Project Code & Schematics Subject: M610 PVT Main Board

<b>FOXCONN</b> HON HAI PRECISION IND. CO., LTD. CPBG - R&D Division		
Title	Index Page	
Size A3	Document Number (M610-1-01) MainBoard (MBX-176) 2007.1.4	Rev 2.0
Date:	Thursday, May 10, 2007	Sheet 1 of 77

Red texts:  
New modified

Title: **VGA (POWER) 7 OF 8**

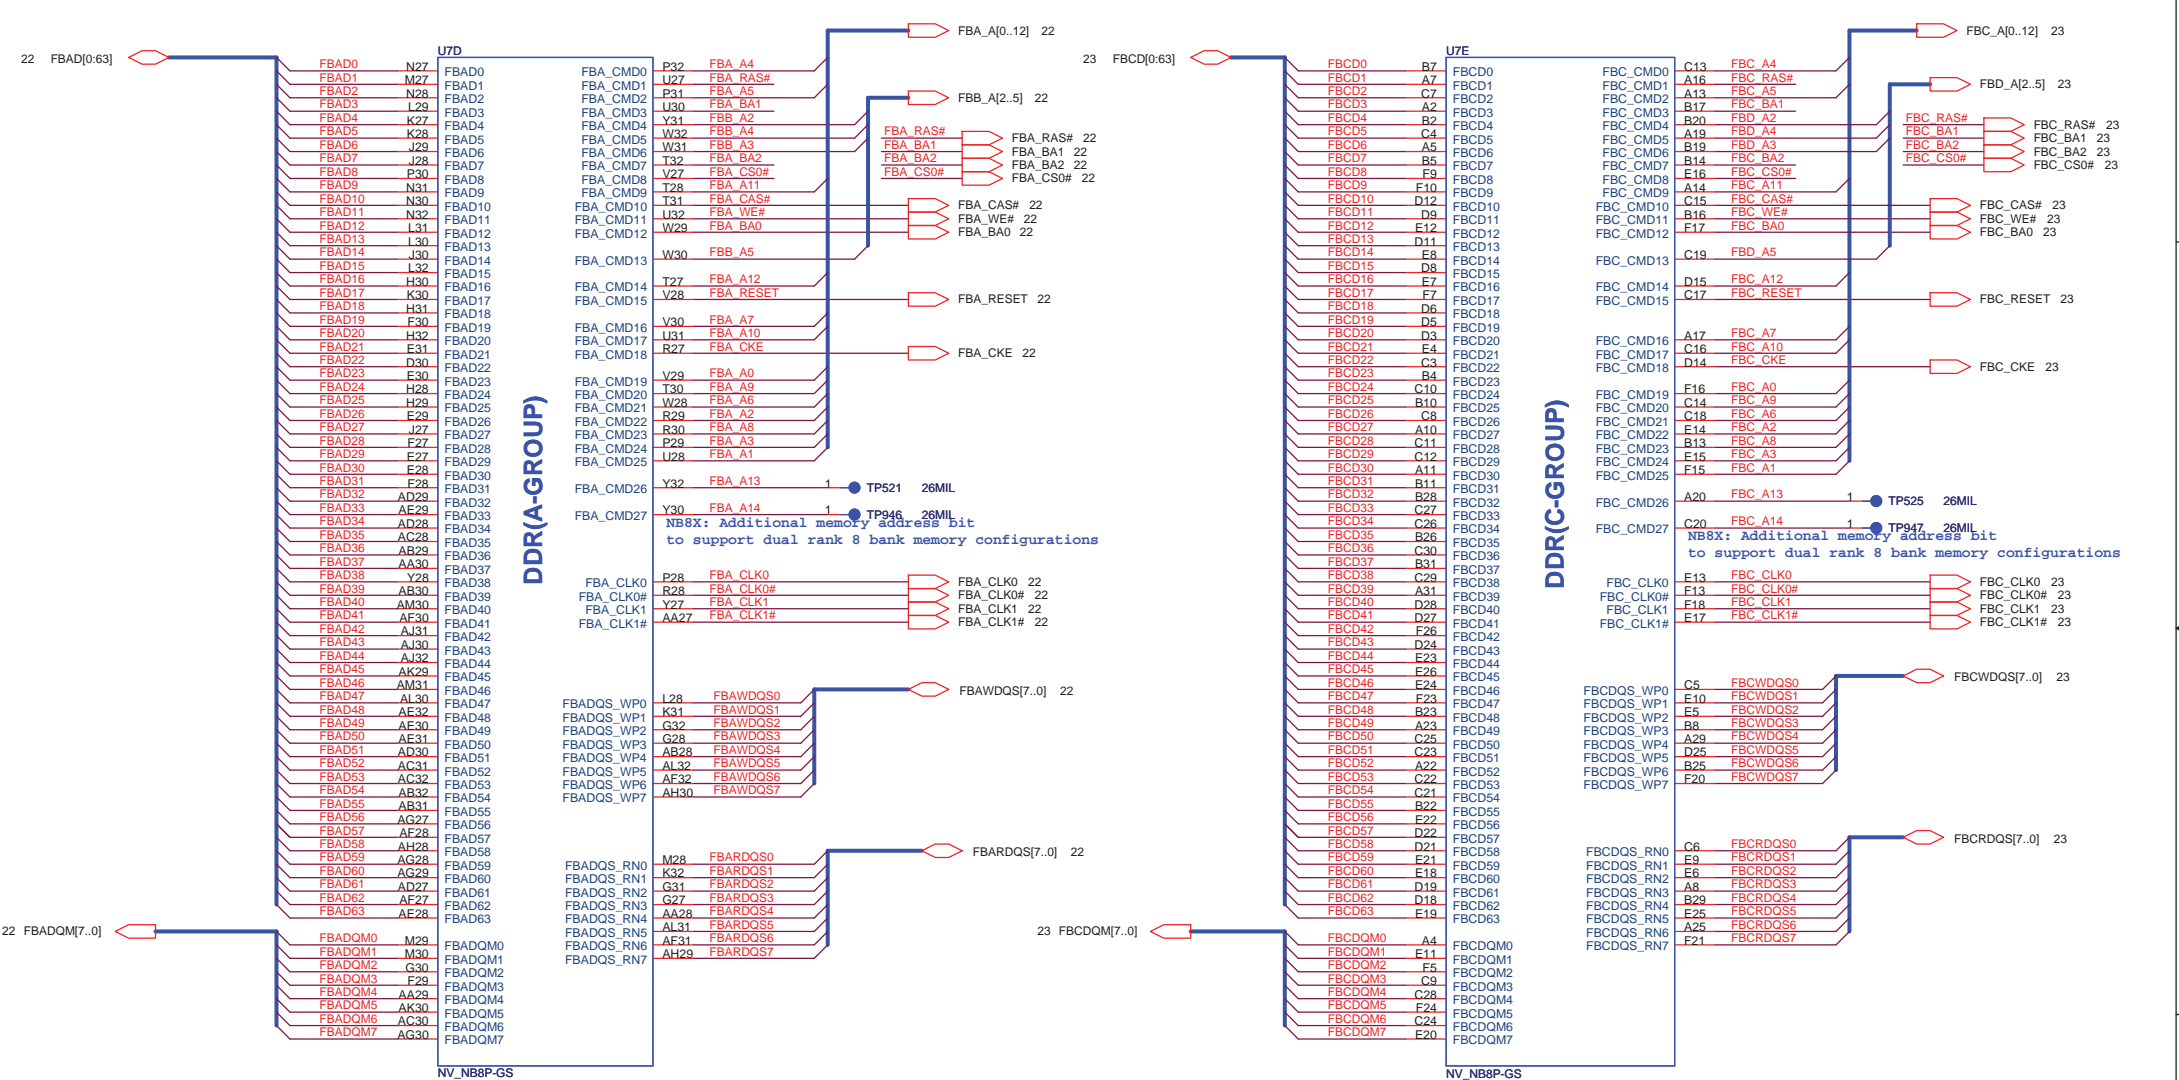
*NB8M-GT Device ID setting mismatch between VBIOS and H/W Straps  
 Change R231 value from NC\_ to NV8M\_  
 Change R232 value from NV\_ to NV8P\_*

Use GPU internal thermal sensor  
Change R2328, R2329 form NC to mount

11/16 change part from F75383M(VERSION:0.28P) (15-F75383M-1000) to G781P8F (15-G781P80-0000)  
Backup GPIO8 for GPU thermal trigger signal  
Change R293 from mount to NC for using internal thermal sensor

NVIDIA FAB suggestion:  
Change GPU thermal alert signal input from GPIO8 to GPIO9.  
Delete TP522 and pull-up GPIO8 (R2332 2.2K to +3VRUN)

9/18 FAE suggest If use internal spread function, U10 and related components can be NC.  
10/19 Change R319, R320 from NC\_ to NV\_ for use internal spread spectrum.

Change R2333 from NC to mount for using internal thermal sensor
